ADDENDUM NUMBER TWO
TO
REQUEST FOR BIDS, CONTRACT DOCUMENTS, CONSTRUCTION
SPECIFICATIONS AND DRAWINGS
FOR CONSTRUCTION OF

STATE ROUTE 21
SIDEWALK IMPROVEMENTS
FOR
THE CITY OF PORT WENTWORTH, GEORGIA

**STATE ROUTE 21
 SIDEWALK IMPROVEMENTS FOR
 THE CITY OF PORT WENTWORTH**

SHEET NUMBER:
C-03

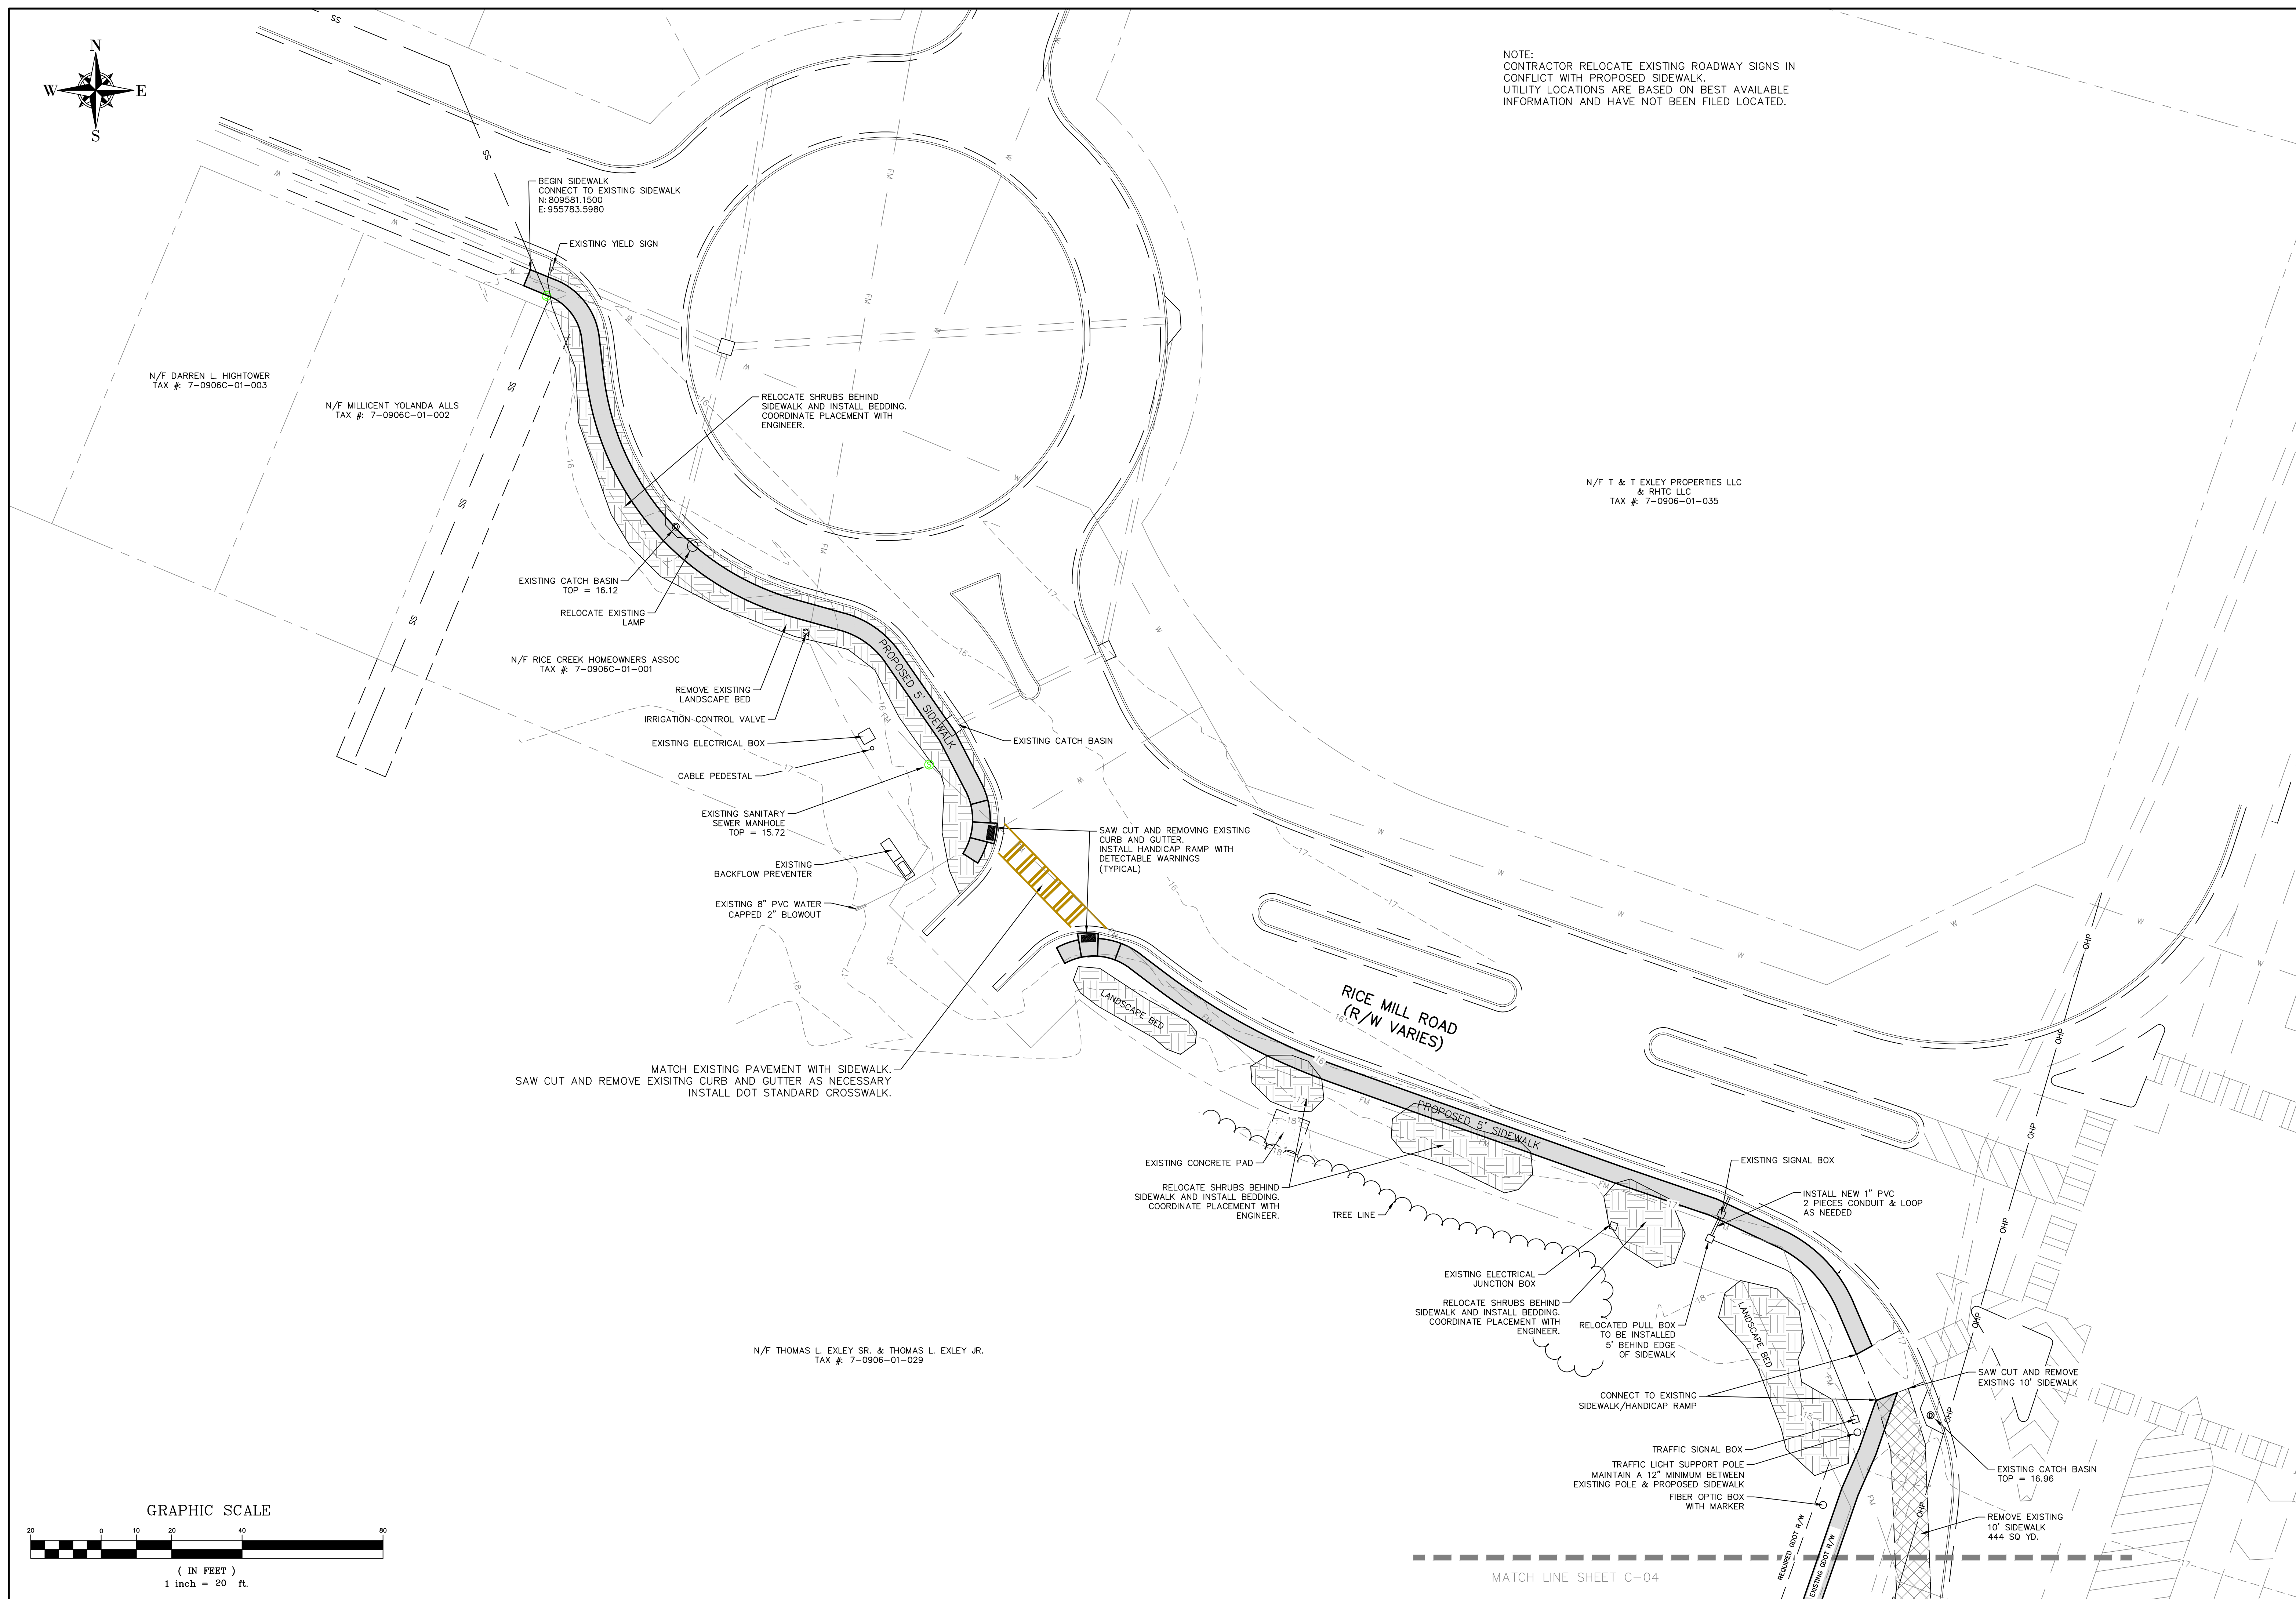
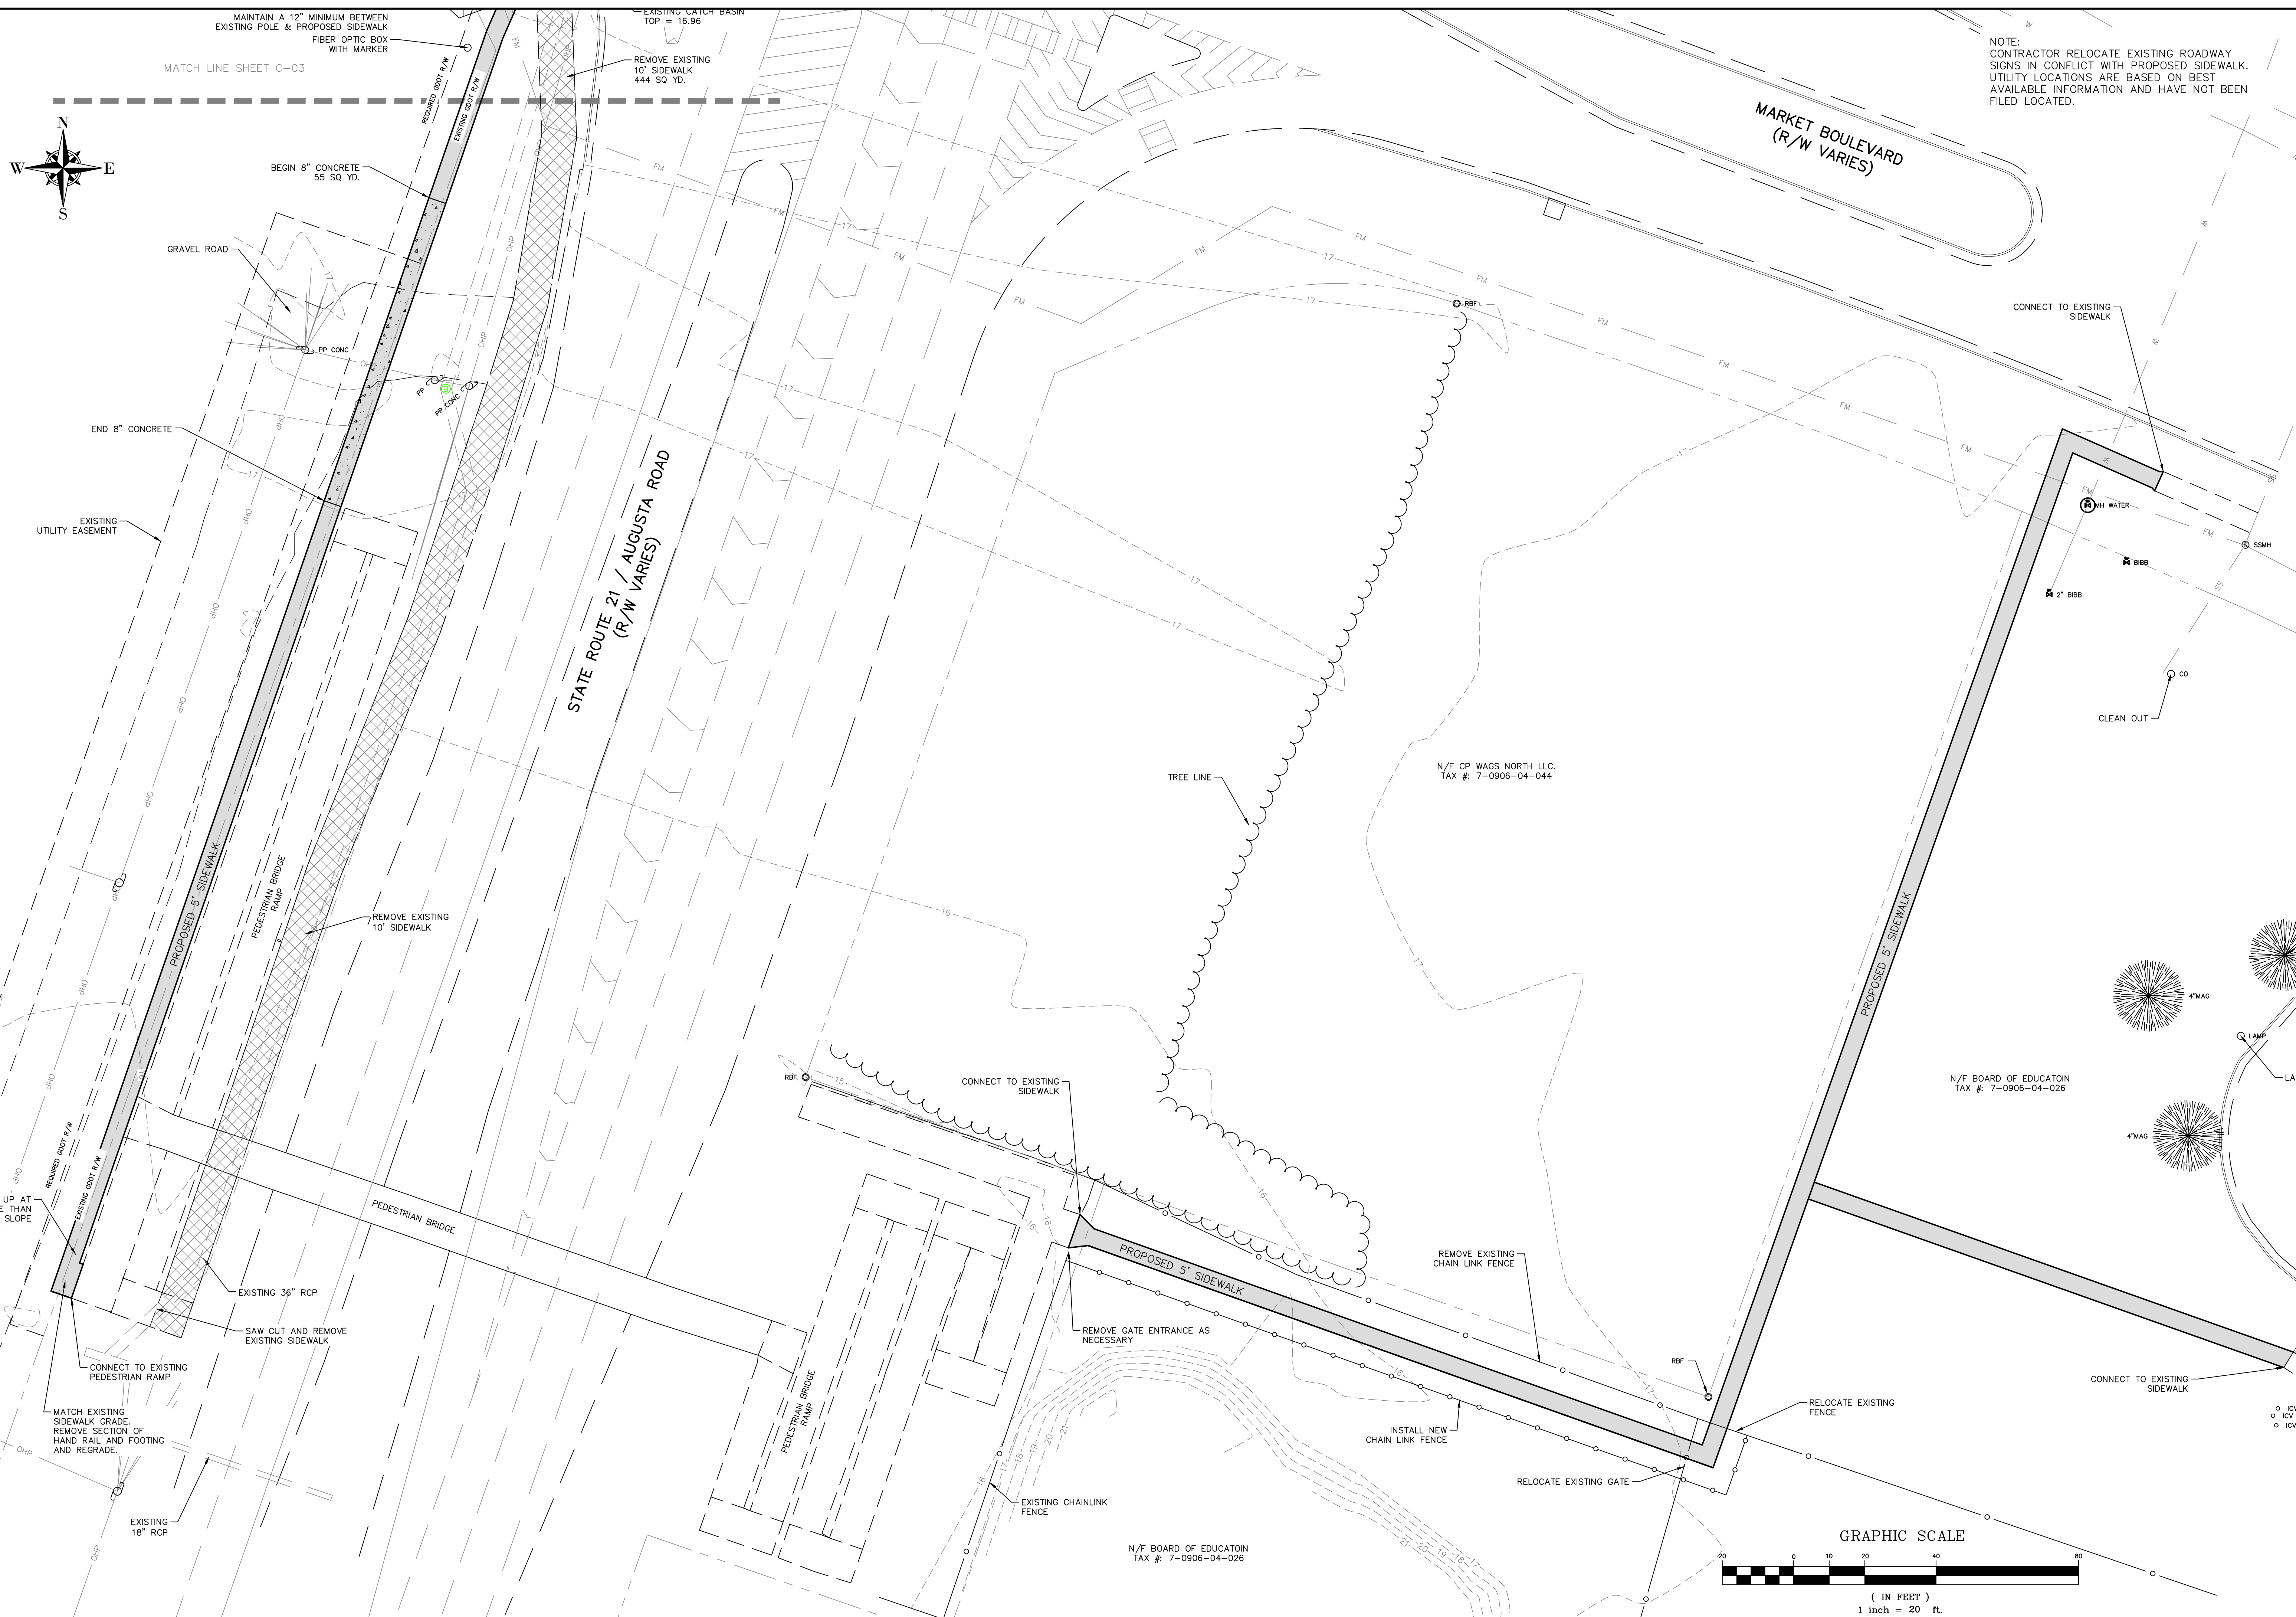
2. Note of clarity on Construction Plans.
 - a. The existing shrubs and bedding along Rice Mill Road are to be relocated behind sidewalk.
 - b. The lamp post shall be relocated using the existing fixture and a new foundation. Pour foundation to match existing.
 - c. The existing irrigation system along Rice Mill Road to be relocated behind the sidewalk as needed. This item should be included in grading modified.
 - d. As shown on the revised plan only one section of handrail will be removed. When necessary voids left from the removal shall be completely restored.
